**STATE OF NEW HAMPSHIRE
BEFORE THE
SITE EVALUATION COMMITTEE**

Docket No. 2015-06

**JOINT APPLICATION OF NORTHERN PASS TRANSMISSION LLC
AND PUBLIC SERVICE COMPANY OF NEW HAMPSHIRE
D/B/A EVERSORCC ENERGY FOR A CERTIFICATE OF SITE AND FACILITY**

**PREFILED DIRECT TESTIMONY OF
MICHAEL BUSCHER, JAMES PALMER AND JEREMY OWENS
ON BEHALF OF
COUNSEL FOR THE PUBLIC**

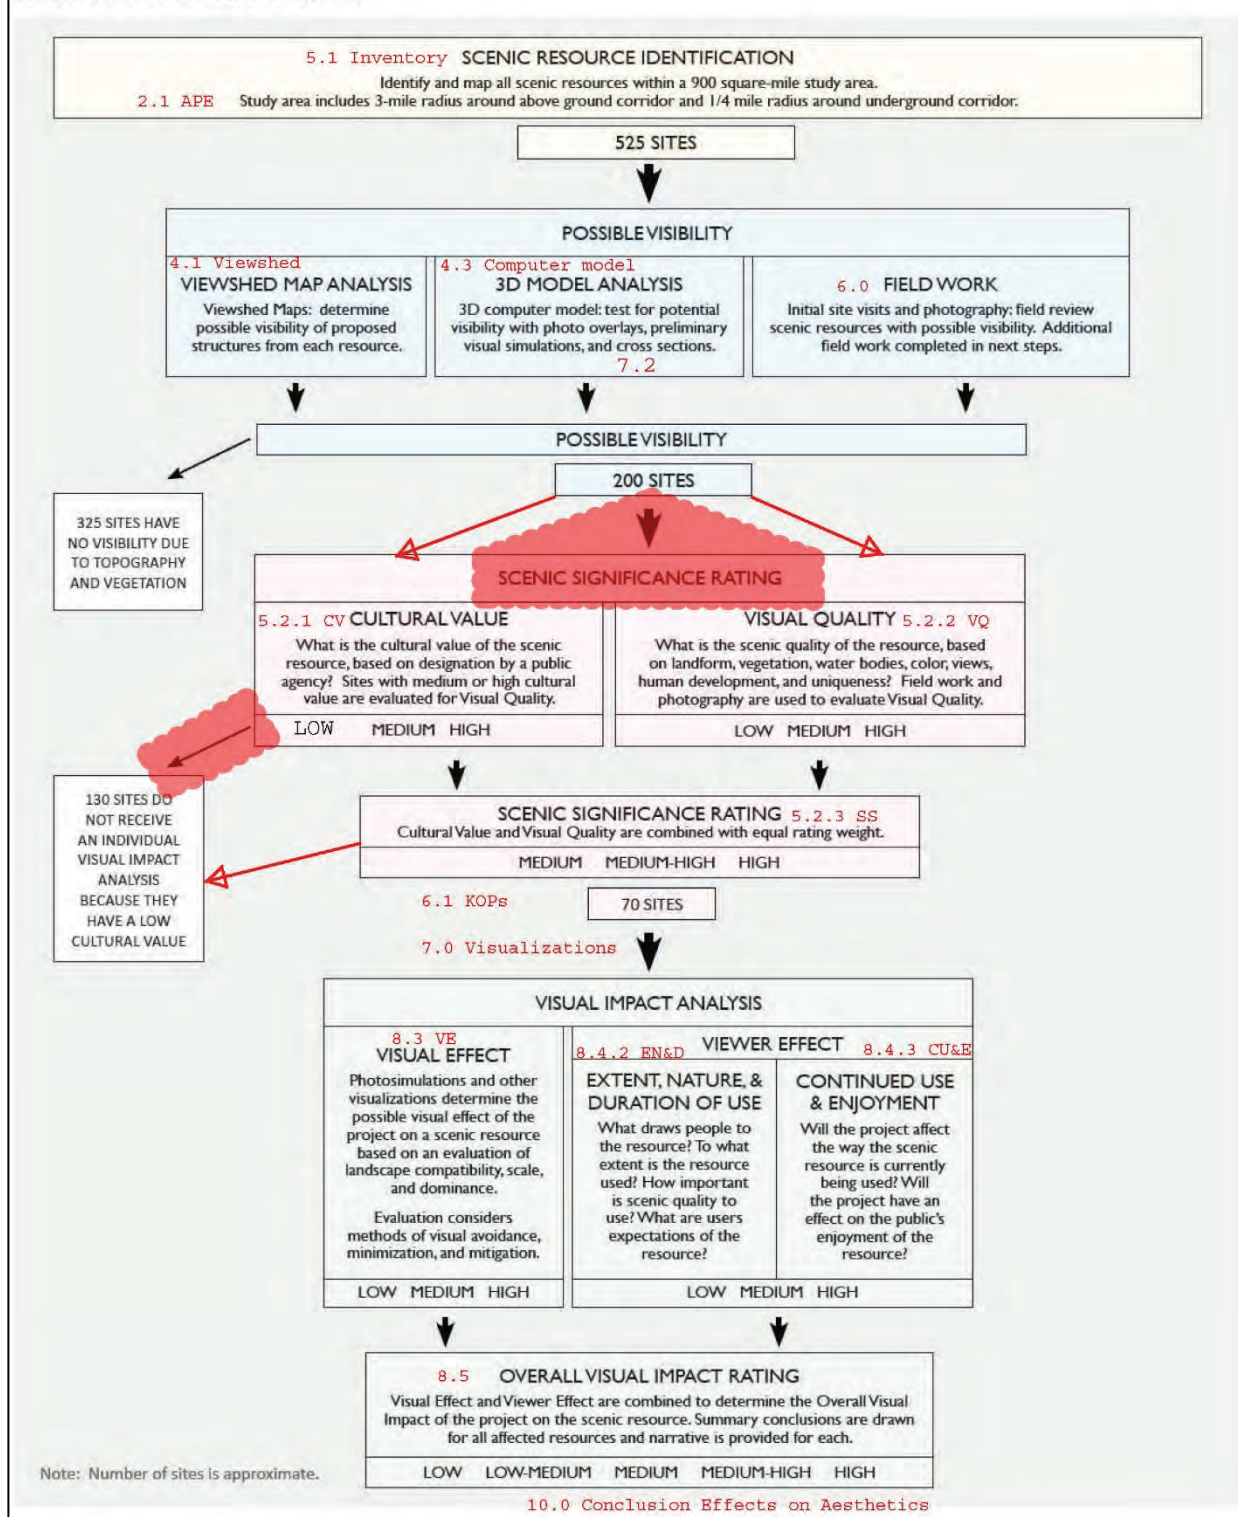
The 3D Model Analysis procedures used in the NPT VIA are reviewed in section 3.7, which discusses visualizations. The NPT VIA identifies 70 KOPs and scenic resources, some of which overlap with each other, for individual Visual Impact Analysis. DeWan & Associates created visualizations for 28 of these KOPs—the selection of these viewpoints is reviewed in section 3.7.1, the photography in section 3.7.2, and the construction of the photosimulations in section 3.7.3. All 70 KOPs, including those without photosimulations, are evaluated in the NPT VIA for their Overall Visual Impacts, which is composed of separate two parts—Visual Effect and Viewer Effect. DeWan & Associates' procedures for determining Visual Effect are reviewed in section 3.8; the components of Viewer Effect are reviewed in sections 3.9 and 3.10. DeWan & Associates' Visual Effect and Viewer Effect results are combined into the Overall Visual Impact Rating, which is reviewed in section 3.11. Section 3.13 reviews the approaches to mitigation identified by the NPT VIA. The final section presents our conclusions from reviewing the NPT VIA.

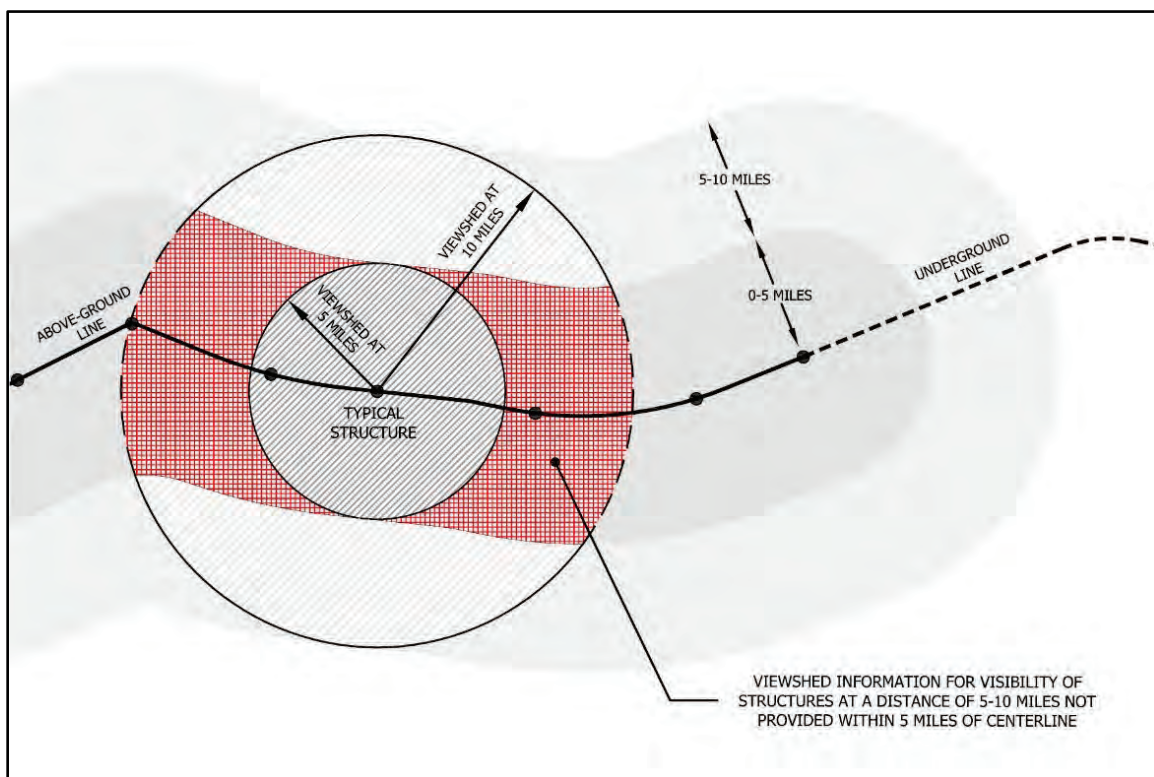
Error in calculating screened visibility. To extend the visibility analysis out to the full 10 miles, DeWan & Associates conducted two separate visibility analyses. The first was for a radius to 5 miles from each structure and was the analysis DeWan & Associates used in the NPT VIA (2015). DeWan & Associates conducted a second visibility analysis for the area between 5 and 10 miles from the NPT centerline and submitted this analysis as part of the February 2016 revisions. The results of both analyses were provided as part of the discovery process. Our inspection of these two visibility maps and parameters used in the viewsheds identified a gap in the analysis—visibility of a structure from a distance of 5 to 10 miles is not determined if the viewer is within 5 miles of the NPT centerline, as illustrated in Figure 3. This is illustrated in Figure 4, which compares the 5 to 10-mile visibility analysis as calculated for the NPT VIA (2016) and DOE (2015) near where the Project corridor turns in Whitefield. It is readily apparent that NPT VIA on the right side does not show visibility within 5 miles of the Project centerline, but the DOE visibility analysis does.

Figure 11. This screen shot shows the original 4,496-by-3,000-pixel photograph of the Coleman State Park entrance and the area cropped for the photosimulation presented in the NPT VIA on page 1-40.

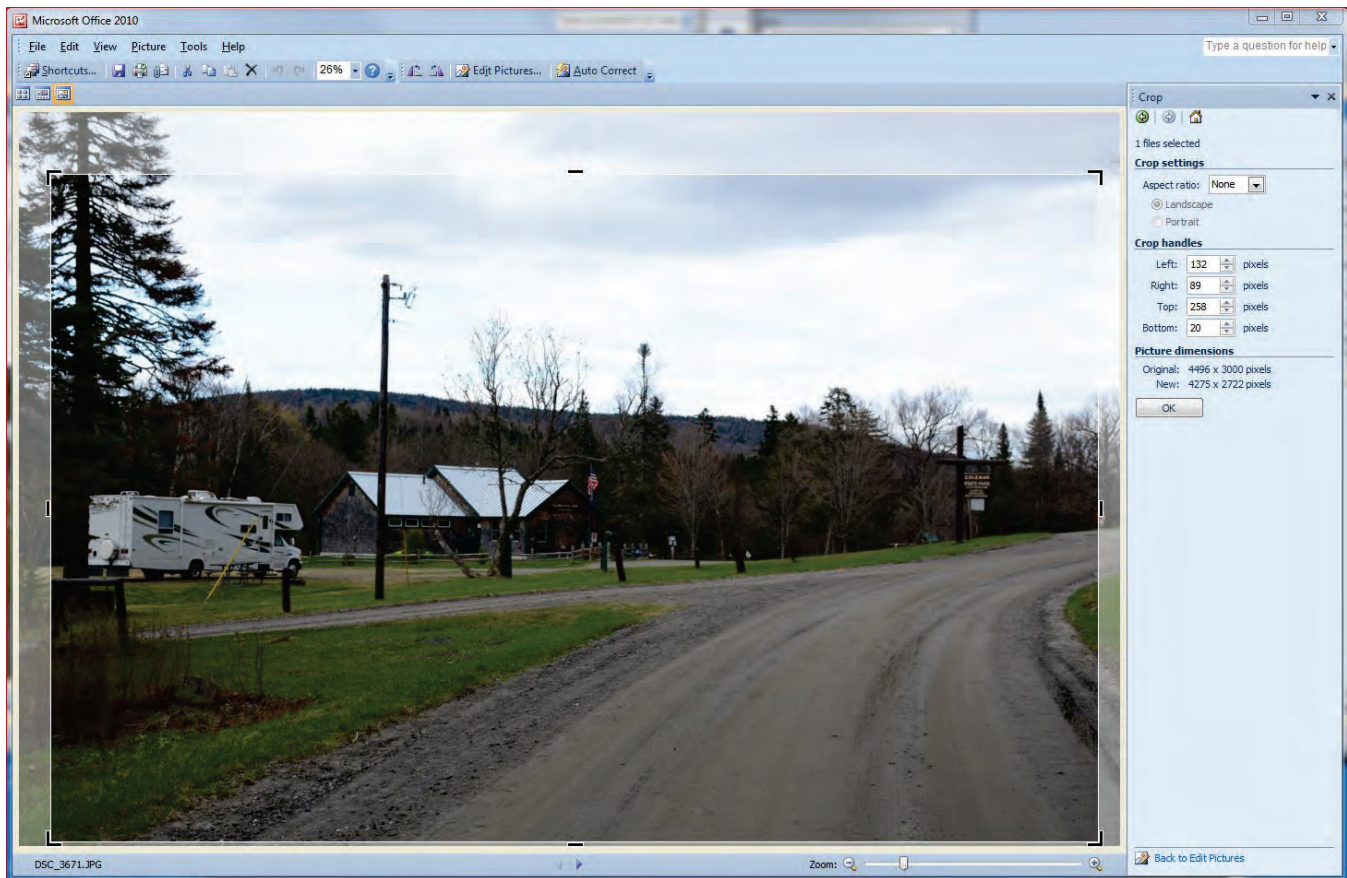
Simulations at 12 of the 28 viewpoints are well below the “high” resolution required by Site 301.05(b)(8)(a). The effect of this lower resolution is to understate the clarity of the potential visual impacts.

Figure 13. An exported image from the Google Earth Pro KMZ file for Lagace Beach provided during discovery, showing that simulating the project from the beach was considered but not carried out.

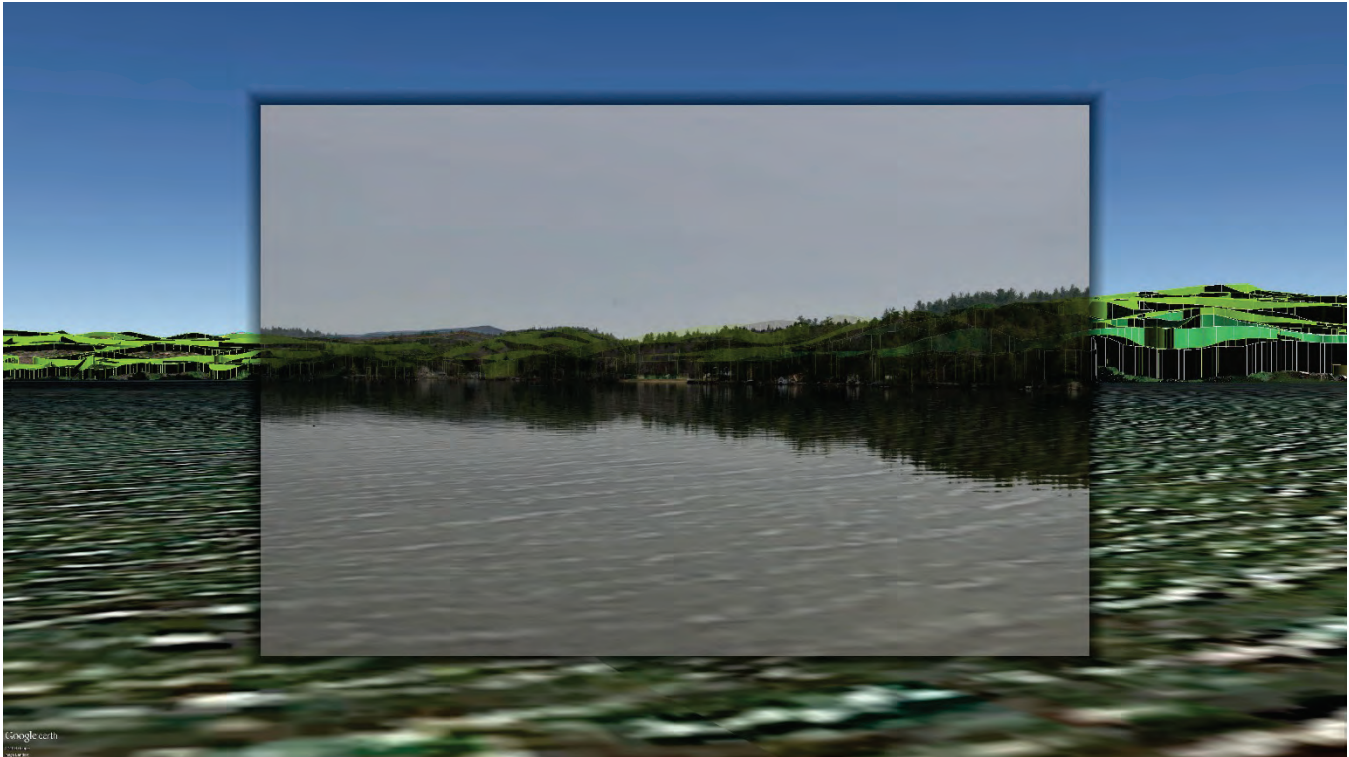
As stated previously, the NPT VIA photosimulation at Lagace Beach in Franklin is not in the direction of project visibility. However, a photograph looking in the direction of visibility was taken by DeWan & Associates and included in the Lagace Beach KMZ file that was provided during discovery (Figure 13). The NPT VIA explicitly notes that NPT structures would be visible from the beach in three locations (NPT VIA at 4-42, photos 3, 5 and 6). However, the photosimulation only depicts a view in the direction where structures would not be visible, with a view description caption that reads "The proposed structures are behind trees in the foreground and will not be visible from this location" (NPT VIA at 4-43). Without reading the text in the NPT VIA and only viewing the information provided in the photosimulation, one is led to believe that there will be no visibility from Lagace Beach.

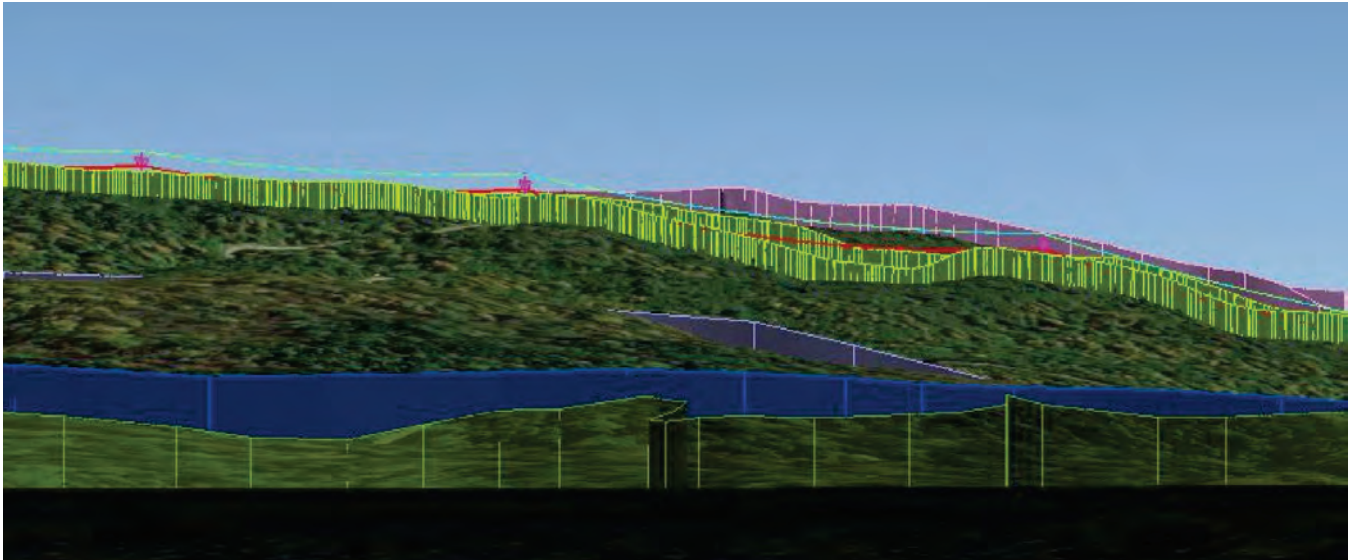
Similar to Turtle Pond, both of the NPT VIA and DOE DEIS include simulations from similar locations at Little Diamond Pond in Stewartstown. Again, we used a simple comparison overlay to determine that the structures visible on the ridgeline are not properly aligned. The KMZ 3D model in Google Earth Pro clearly depicts the proposed structures across the ridgeline and transitioning in front of the ridgeline where the right of way clearing would be visible (Figure 17). When this image was overlaid on the panorama in both the leaf-on and leaf-off conditions, the alignment from the KMZ file does not match the structures that were placed in the image (Figure 18), and the final simulated conditions do not depict the effects of proposed right-of-way clearing (Figure 19).

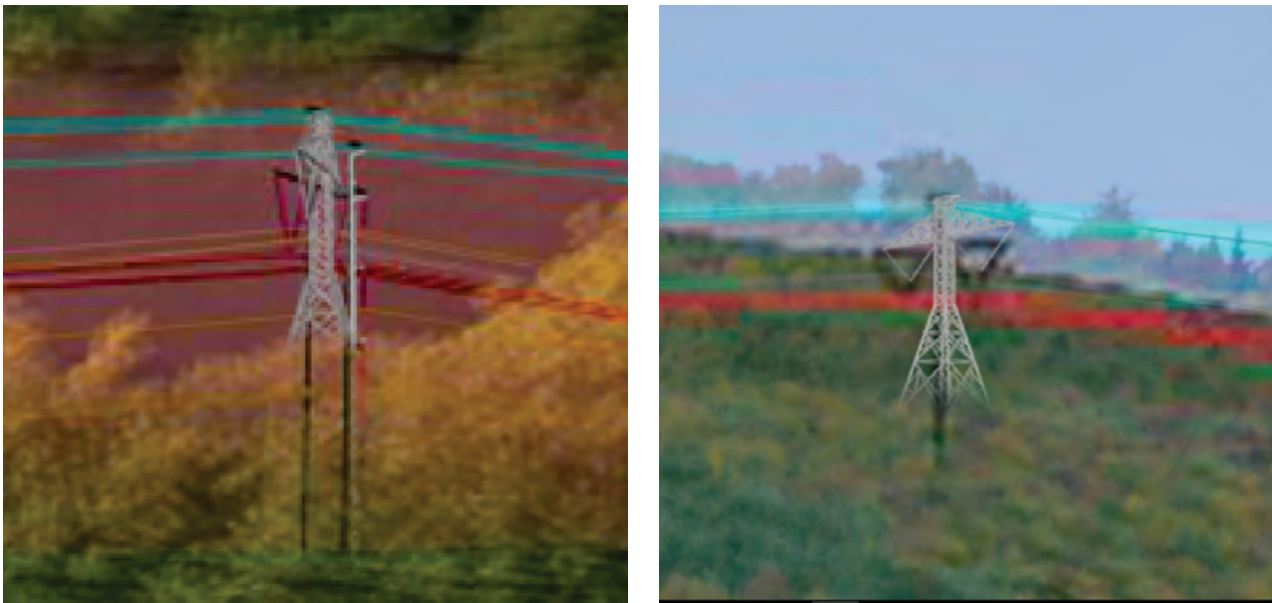
We randomly reviewed the Route 110 and Big Dummer Pond photosimulations to determine the accuracy of placing individual structures in the photosimulation using the method described above. By turning on the KMZ information in the photosimulation files, it becomes evident that some individual structures have been oriented in a way that reduces the profile of the structure (see Figure 21).

Figure 33. Typical vegetation mitigation plan in DeWan & Associates' Roadside Visual Buffer Report, referenced in the MPRP Application (RVBR, p. 19).

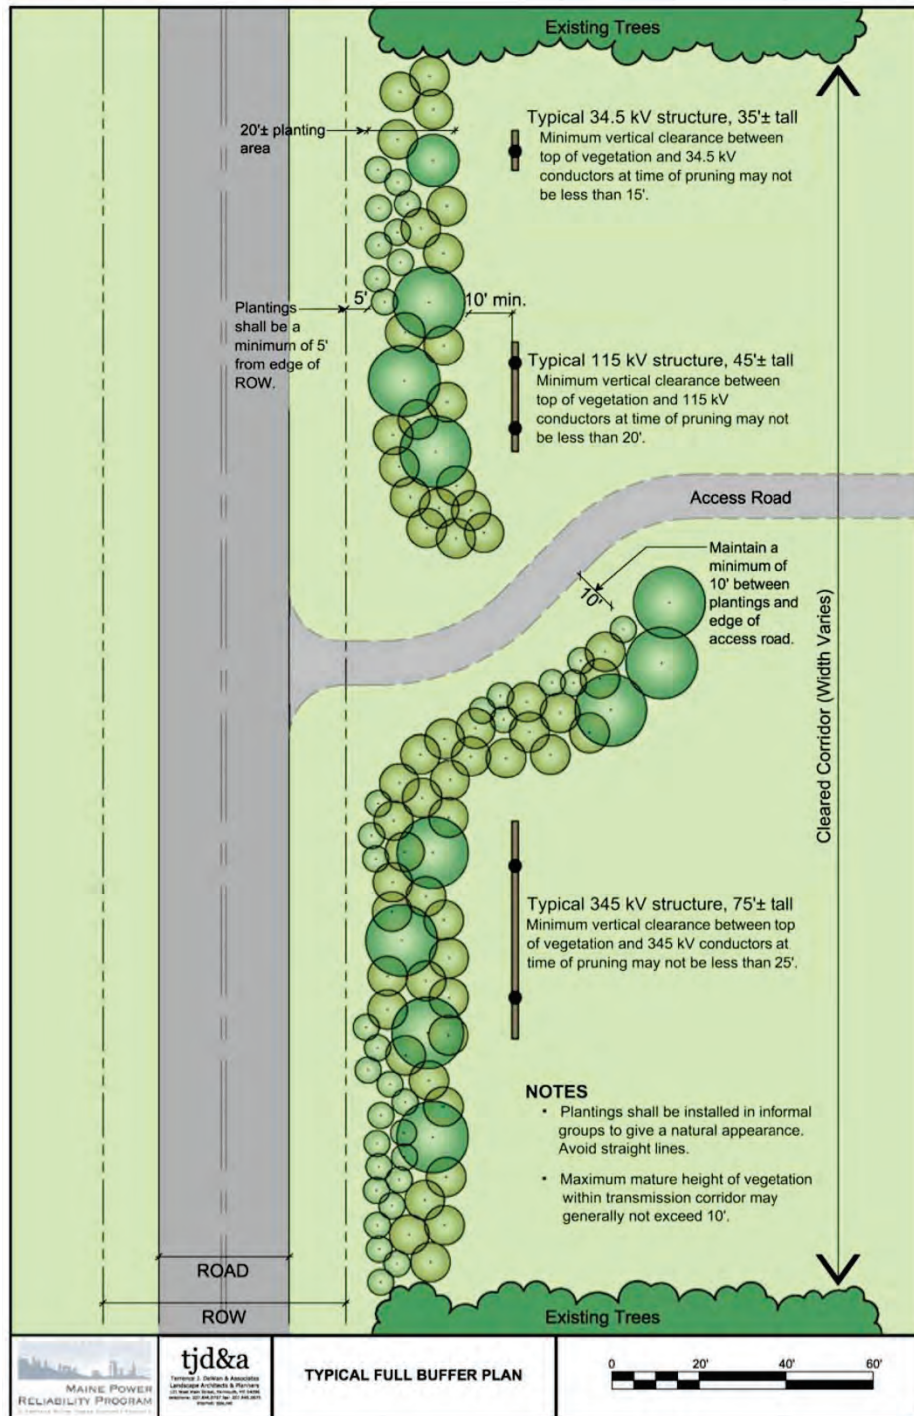
In the case of the MPRP Application, the DeWan & Associates outlined and instituted the method for determining vegetative mitigation prior to applying for a permit. Dewan & Associates also provided examples of how this form of mitigation would be employed and a list of proposed plantings were provided. This allows the reviewing body to assess the proposed impacts as well as the proposed method to mitigate those impacts.
